CPSES-200501556 Log # TXX-05127 File # 00236

August 22, 2005

- SUBJECT: COMANCHE PEAK STEAM ELECTRIC STATION (CPSES) DOCKET NOS. 50-445 AND 50-446 LICENSE AMENDMENT REQUEST (LAR) 05-005 REVISION TO TECHNICAL SPECIFICATION 3.7.10, "CONTROL ROOM EMERGENCY FILTRATION/PRESSURIZATION SYSTEM (CREFS)"
- REF: 1) NRC Generic Letter 2003-01, "Control Room Habitability," June 12, 2003
 - 2) TXU Power Letter, Logged TXX-03158, from Mike Blevins to Nuclear Regulatory Commission, dated December 4, 2003

TABLE OF CONTENTS (continued)

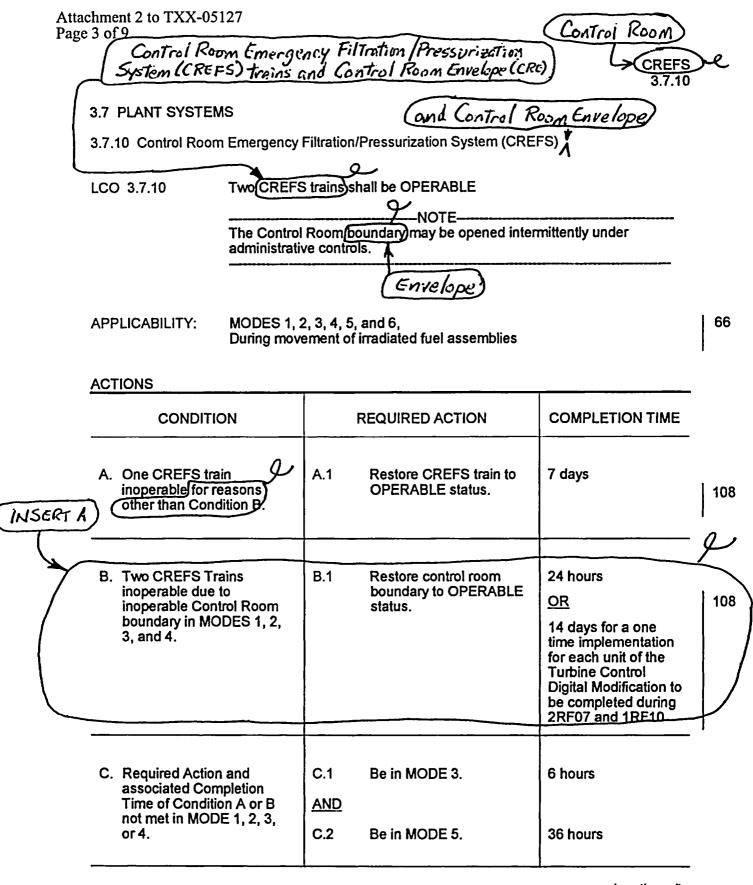
and Control Room Envelope (CRE)

B.3.7.10

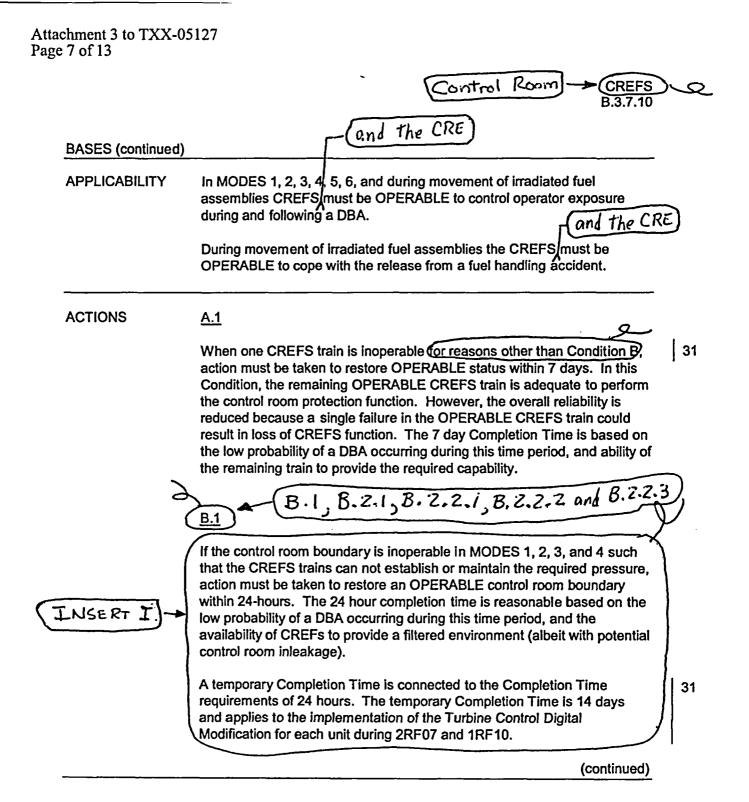
LCO	Two independent and redundant CREFS trains are required to be OPERABLE to ensure that at least one is available assuming a single failure disables the other train. Total system failure could result in exceeding a dose of 5 rem to the control room operator in the event of large radioactive release.	
	The CREFS is considered OPERABLE when the individual component necessary to limit operator exposure are OPERABLE in both trains. A CREFS train is OPERABLE when both filtration units (i.e., the emerge pressurization unit (EPU) and emergency filtration unit (EFU)) are OPERABLE. A filtration unit is OPERABLE when the associated:	Ą

a. Fan is OPERABLE;	
	b. HEPA filters and charcoal adsorbers are not excessively restr flow, and are capable of performing their filtration functions (th EFU must meet Ventilation Filter Testing Program (VFTP) requirements; the EPU must meet VFTP requirements, excep filtration requirements); and	ie

c. Heater (EPU only), demister (EPU only), ductwork, valves, and dampers are OPERABLE, and air circulation can be maintained	
	In addition, the control room boundary must be maintained, including the integrity of the walls, floors, ceilings, ductwork, and acce doors.	ISS
NSERT H	The LCO is modified by a Note allowing the Control Room boundary to opened intermittently under administrative controls. For entry and exi- through doors the administrative control of the opening is performed to the person(s) entering or exiting the area. For other openings these controls consist of stationing a dedicated individual at the opening when n continuous communication with the control room. This individual we have a method to rapidly close the opening when needed for control r solation.	it Dy Io is ill
